SUSQUEHANNA RIVER BASIN
KEHM RUN DAM
DR. RAY W. KEHM

NDI NO. PA-01029
DER NO. 67-483

YORK COUNTY, PENNSYLVANIA
PHASE I INSPECTION REPORT
NATIONAL DAM INSPECTION PROGRAM

PHASE I REPORT
NATIONAL DAM INSPECTION PROGRAM

PLATE A-II

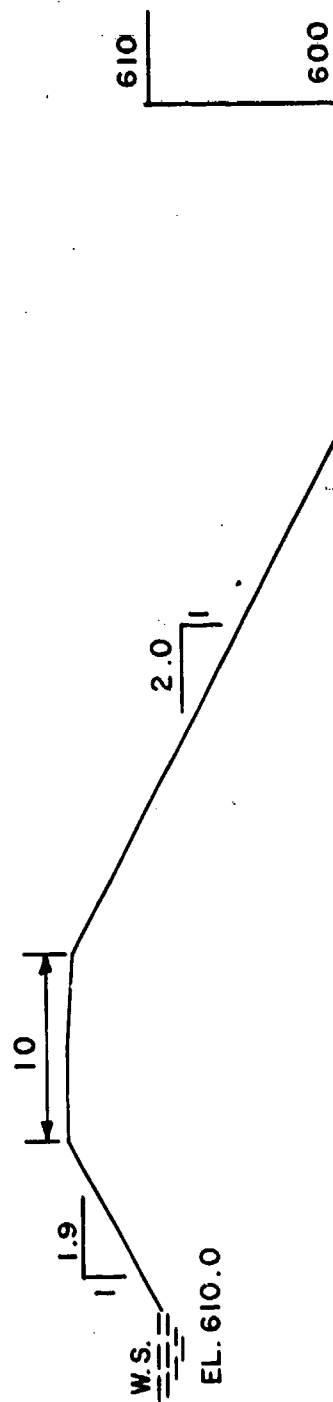
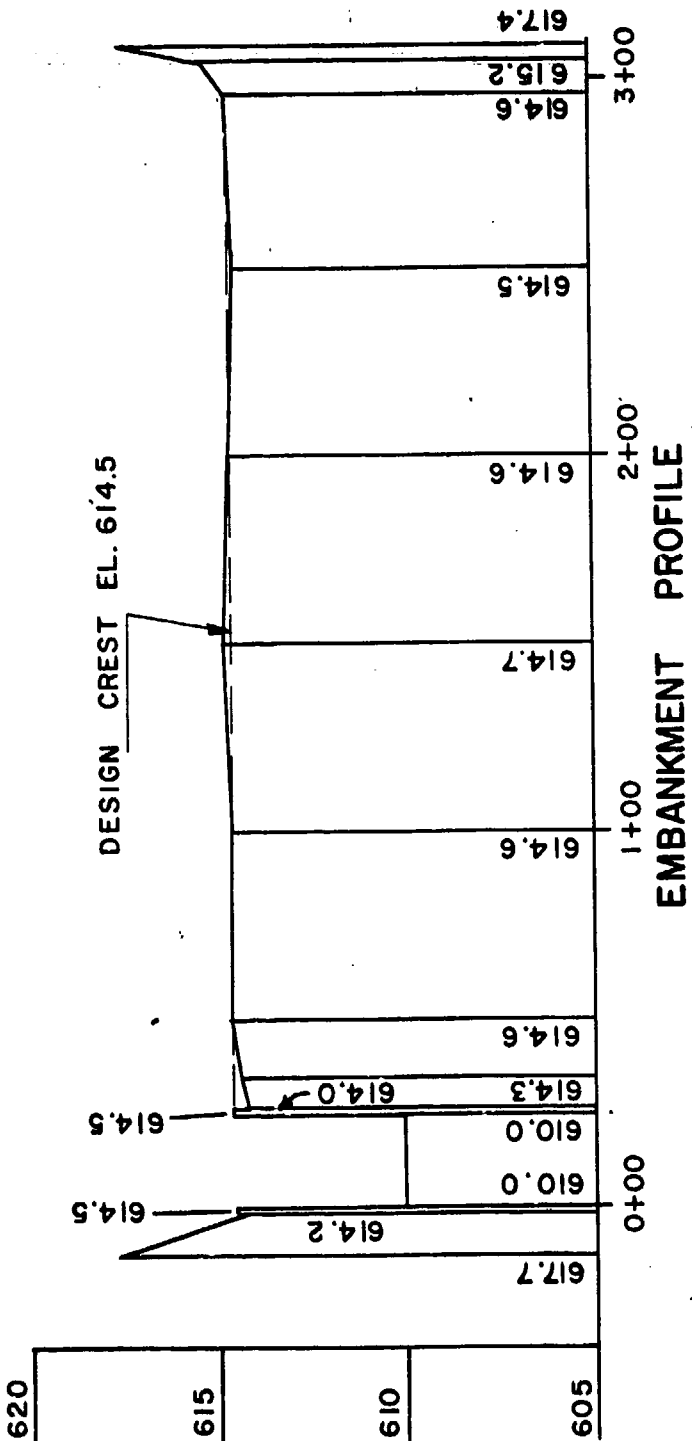
The horizontal alignment of the embankment is good. The vertical profile of the dam (Plate A-II, Appendix A), indicates that the crest of the dam is below the design crest elevation adjacent to the spillway walls.
